**HEGLEY ACOUSTIC
CONSULTANTS**

**Lyttelton Port of Christchurch
Coal Stockyard Expansion Project
Response to Further Information Request - Noise Matters**

The purpose of this report is to answer the questions relating to the noise effects. These are questions 41 (effects of underwater noise) and 46 – 50 (noise effects from the hillside excavation) from Environment Canterbury and questions 13 – 17 from the Christchurch City Council. The report answers the questions in the order set out in those requests.

Figure 2. Existing Ambient Levels

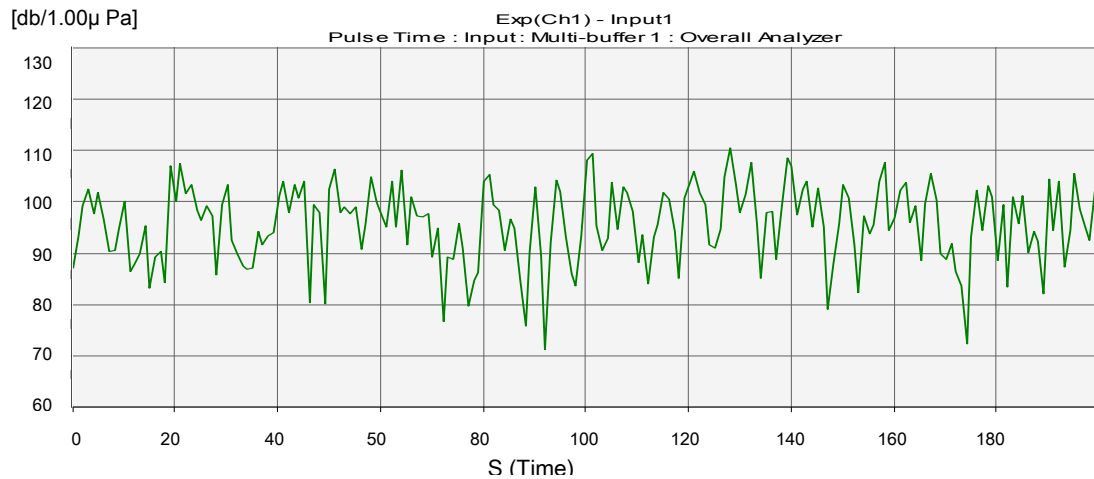
The reclamation and wharf construction activities will generate underwater noise. Please provide details of the expected levels of underwater noise that will be generated by the various activities, and assess the potential underwater acoustic effects on marine ecology, particularly the effects on Hector's dolphins

As shown on Figure 2 the noise level measured over a five minute period (although only part of the trace is included) varied between a low of 72dB re 1 μ Pa to a maximum of 110dB with L_{eq} being 98dB re 1 μ Pa. These are relatively low levels of noise and reflect the calm conditions with no shipping in the area other than general port activities some distance away at the time of the measurements.
